## ***Interactive comment on “Estimating net anthropogenic nitrogen inputs (NANI) in the Lake Dianchi Basin of China” by W. Gao et al.***

**W. Gao et al.**

Received and published: 17 June 2014

[Interactive Comment](#)**Fig. 1.**

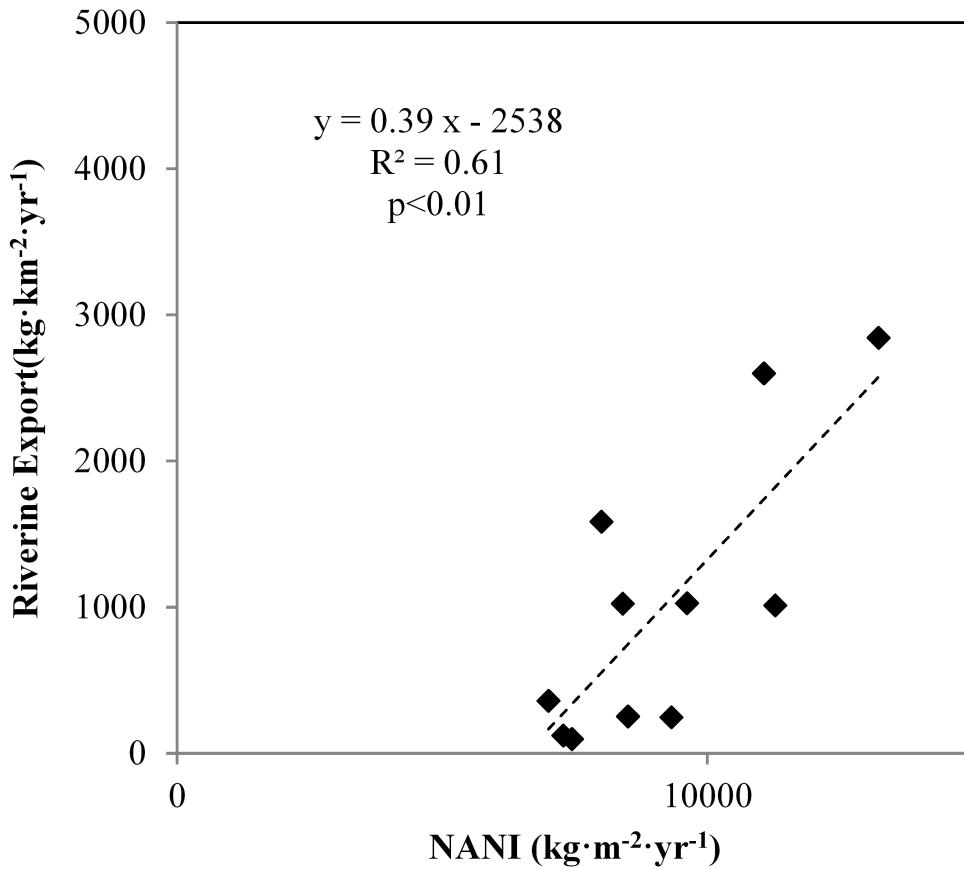
(1) "My wondering point is why you used date of catchment 4, 8 and 14 to make this figure. The catchment of 4, 8, and 14 are exactly different to others in population density and the percentage of urban area. Further, in these catchments, the distance from water treatment plan to water sampling point looks too close to discuss the purification capacity. If you make figure 5 without these three catchments, you will find more good fitting line between NANI and Riverine Export in Fig. (b). Also you will find different value of slope, and y-intercept of the linear fit function. For my roughly estimation, the slope value looks around 0.2 that is not so different value in North America and Europe (the last line of page 6). Also, intercept of X axis might be shifted to small value. If so, your discussion in page 7 will be no point."

(2) "I think that your mistake to make Fig. 5 with all catchment data itself is showing one kind of important reminder or carefully point for using NANI to small area."

Authors' response: Net anthropogenic N inputs (NANI) is calculated from four typical human-induced N sources: fertilizer use, legumes fixation, atmospheric NO<sub>x</sub> deposi-

tion and food & feed imports. While it is true that these three watersheds have the highest population density and proportion of urban land, the aim is to use a single methodology to estimate N inputs irrespective of the character of the landscape, and to eliminate these watersheds would remove the urban end of the spectrum from the analysis. For the three catchments, the high percentage of human population density and urban area indicate that human activities in these areas are very intensive, which is consistent with their high NANI values. If, as you suggest, we delete these three catchments from figure 5 (please see the attached figure 2), a poorer rather than better fitting line results. The slope is still very high (0.61) and the intercept is negative ( $p<0.05$ ), which is consistent with our current results. Instead, we have chosen to examine the effect of estimating the untreated riverine fluxes for these relatively urban watersheds (see reply to comments of reviewer 1), and feel that this approach supports our conclusion about the importance of waste treatment in such systems.

Authors' response: While we agree that dealing with relatively small watersheds is a challenge, we note that watersheds 4, 8 and 14 are not the smallest in the set considered. As noted above, we believe it is important to include the urban watersheds in the analysis even if the high resulting loads influences the result. Further, we think that we have identified an issue perhaps as important as scale in the relationship between NANI and riverine N flux: the extent of N removal in waste treatment in areas of high population density.
